Extract of Previously Submitted Further Information

Table 1	Response-to-Comments
Appendix 1	Revised Planning Statement
Appendix 2	Revised Environmental Assessment
Appendix 3	Revised Drainage Impact Assessment
Appendix 4	Figure RC-01

Re: Section 16 Planning Application for Proposed Temporary Cold Storage for Poultry and Distribution Centre for a Period of 3 Years and Filling of Land for Site Formation Works at Lots 471 S.B RP (Part), 472, 473, 474, 475, 476, 483, 501, 502, 504 S.B, 505 and 506 S.B RP in D.D. 89 and Adjoining Government Land, Man Kam To Road, Sha Ling, New Territories

Section 16 Planning Application No. A/NE-FTA/220

Figure 3-1: Identification of Surrounding Catchments

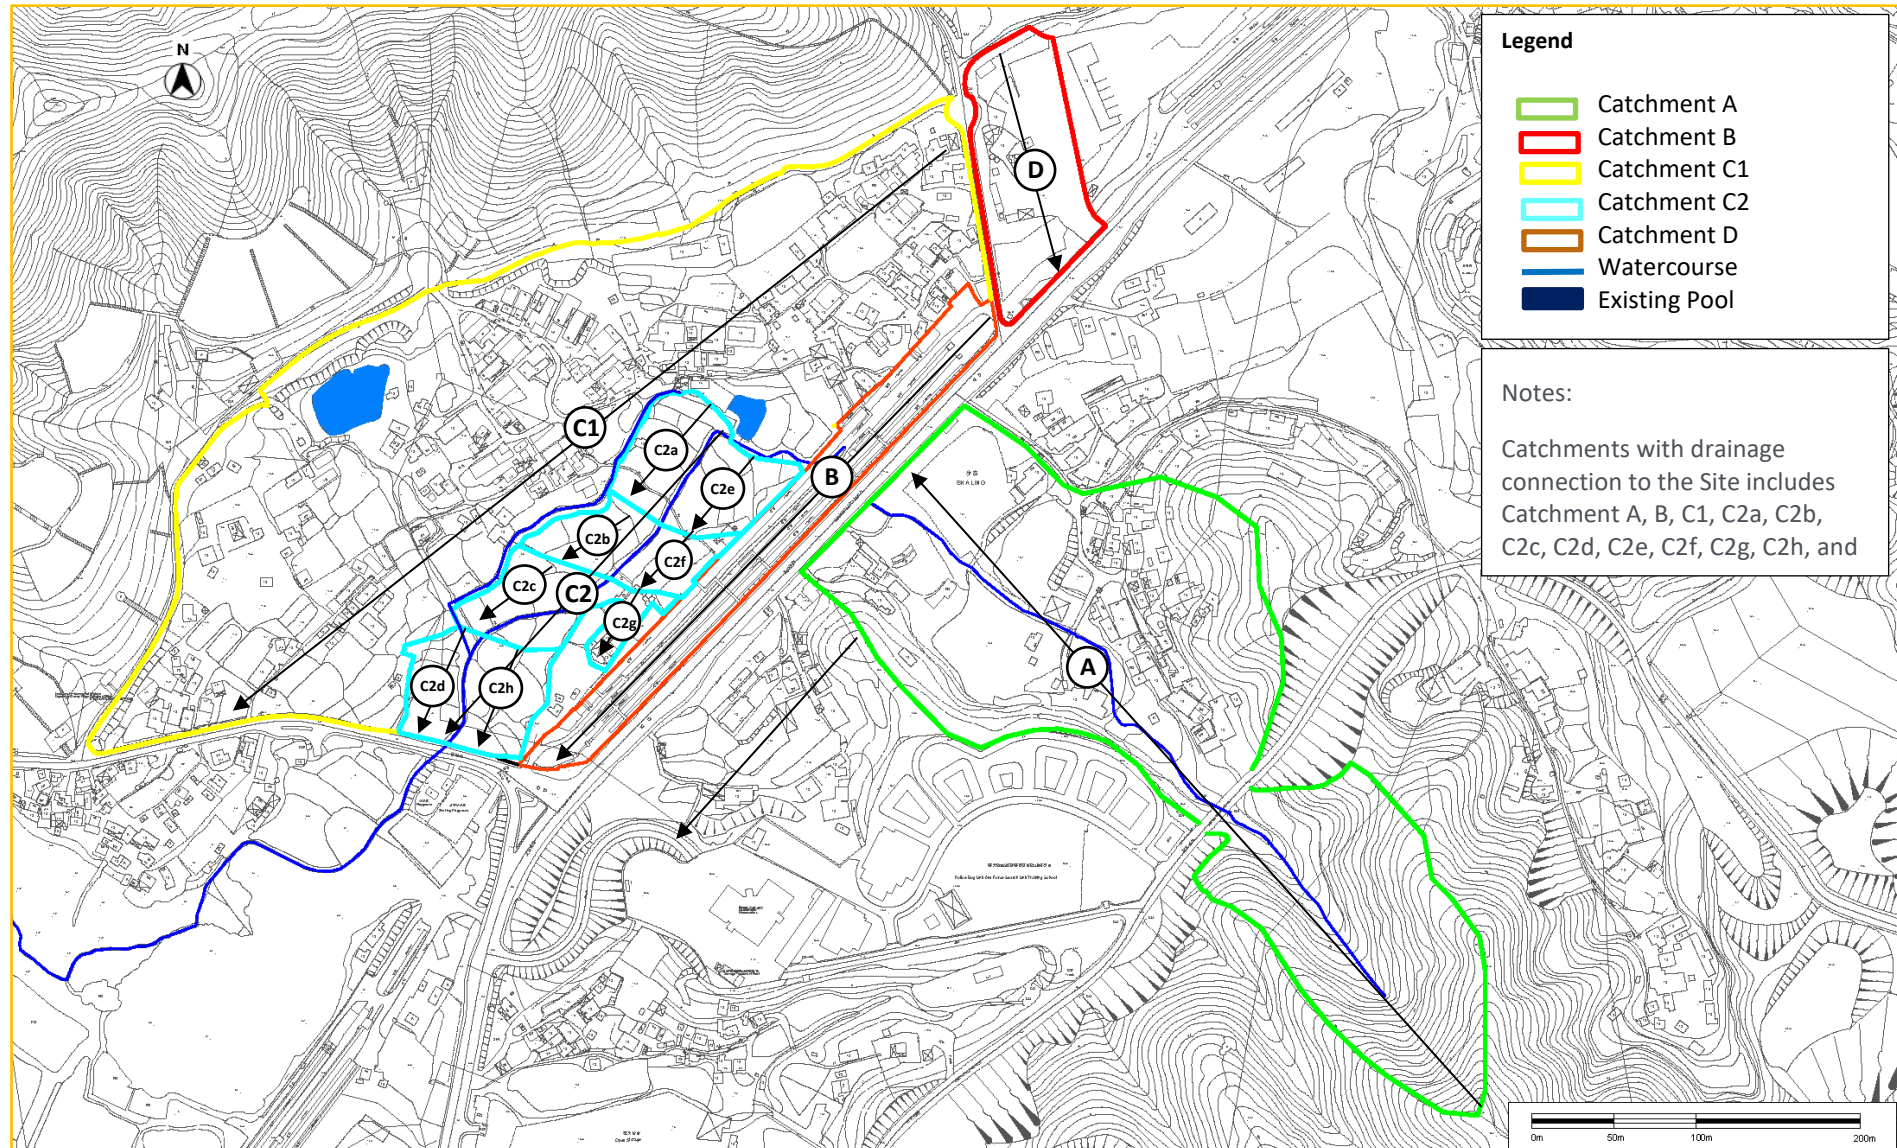
<p>3. Para. 3.2.8 refers. The photos of relevant watercourse are missing in the Figure 3-1 and the submission.</p>	<p>The photos of relevant watercourse are added in the Figure 3-1 (Appendix 3 refers).</p>
		<p>4. Para. 3.6.12 refers. It is mentioned that “part of the flow will adopt another arrangement at the catch pits CP7 and MH15 where partial stormwater will bypass the proposed Uchannel and overflow into the proposed underground stormwater storage tank”. Please elaborate on the mechanism of separating the partial stormwater and the proposed underground stormwater storage tank. Please also specify under what condition that the concerned mechanism will be triggered.</p>	<p>Para 3.6.12 has been revised (Appendix 3 refers).</p>
		<p>5. Para. 3.6.14 refers.</p> <p>i. Please provide the decking over details and proposed</p>	<p>i) The existing watercourse (about 1.5 m (W) x 0.9 m (D)) running in a northeast to southwest direction of the Site will be maintained and</p>

Figure 3-2: Indicative Proposed Drainage Layout

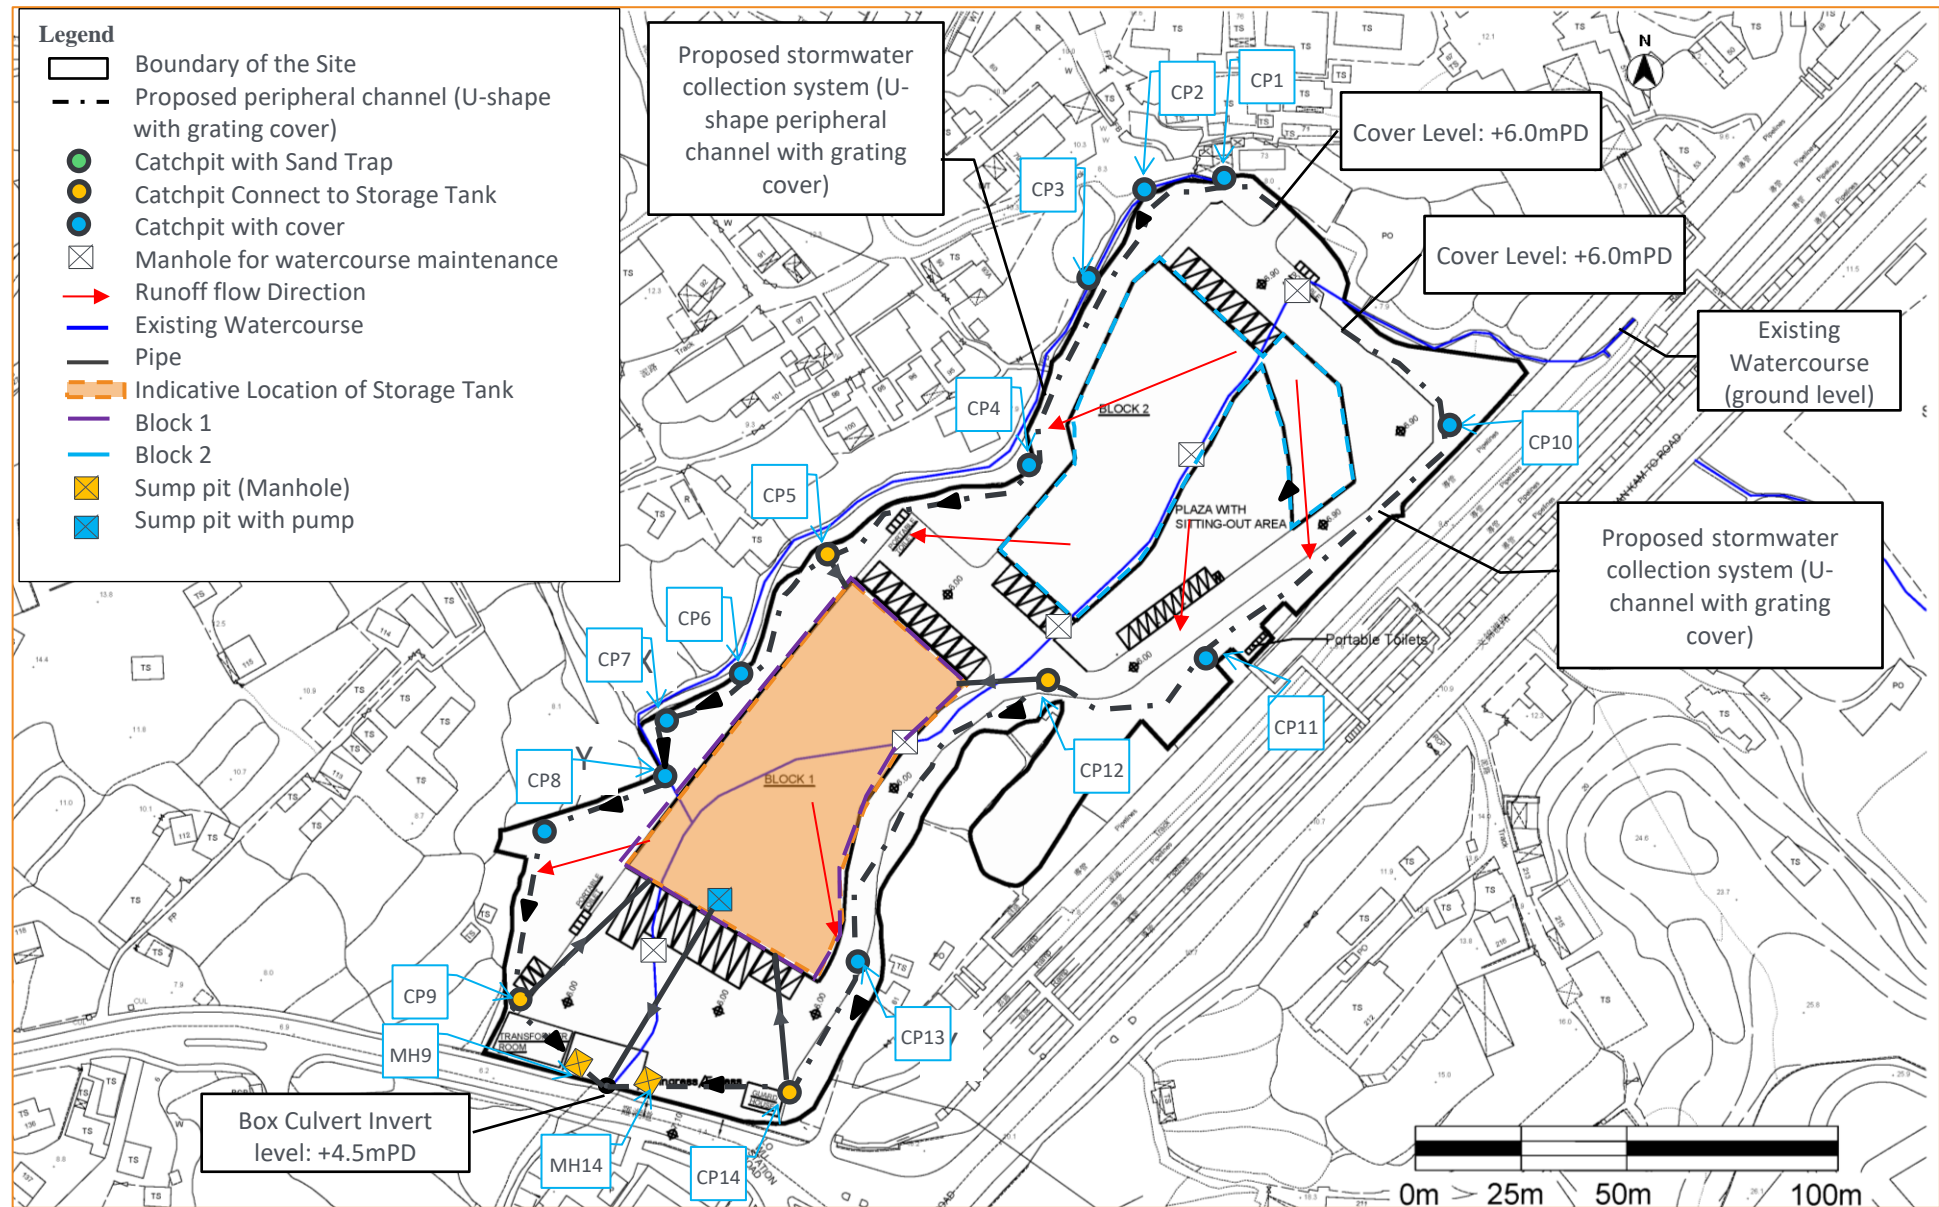
<p>6. Figure 3-2 refers.</p> <p>i. Please provide future ground levels to substantiate the flow</p>	<p>Please refer to Appendix 3.</p> <p>i) The indicative future ground levels are indicated in Figure 3-2</p>

Date	Bureau / Department	Comments	Responses
		<p>path;</p> <p>ii. Please provide the details for flexible drains connection;</p> <p>iii. The details (invert level, gradient, general sections etc.) of the proposed drain/ surface channel, catchpits and the discharge structure shall be provided;</p> <p>iv. The cover levels of proposed channels should be flush with the existing adjoining ground level;</p> <p>v. Please provide details for MH7, MH9 and MH15; and</p> <p>vi. The surface runoff from the plant rooms at southeast corner of the proposed development is not properly collected, please review.</p>	<p>ii) Diagram showing the connection arrangement is in Figure 3.2. Pipe drains connection is adopted.</p> <p>iii) Figure 3-2 is revised to include invert levels and gradient. Please also refer to Appendix C and E for the general sections of the proposed drain/ surface channel, catchpits and the discharge structure.</p> <p>iv)Noted, cover levels of proposed channels will be flushed with existing adjoining ground level as far as possible.</p> <p>v) Manhole design will be based on DSD standard manhole drawings. Details will be provided in detailed design stage after planning application is approved.</p> <p>vi) The drainage arrangement at the southeast corner has been adjusted such that U-channels are arranged along the entrance of plant rooms. There will be drainage fall leading surface runoff into the U-channels.</p>

Date	Department	Comments	Responses
		<p>and 0.06 m³/s were adopted for the total runoff, where both were values not well represented in the runoff calculations (Appendix A). Please review and clarify.</p>	<p>Catchment 2a will likely result in overdesign. The description is only to indicate the catchments involved in the calculation.</p>
		<p>7. 3.6.13 and Figure 3-2: MH 15 mentioned in 3.6.13 is missing in Figure 3-2. Please review and clarify.</p>	<p>Typo. The MH15 is correct. Figure 3-2 has been revised.</p>
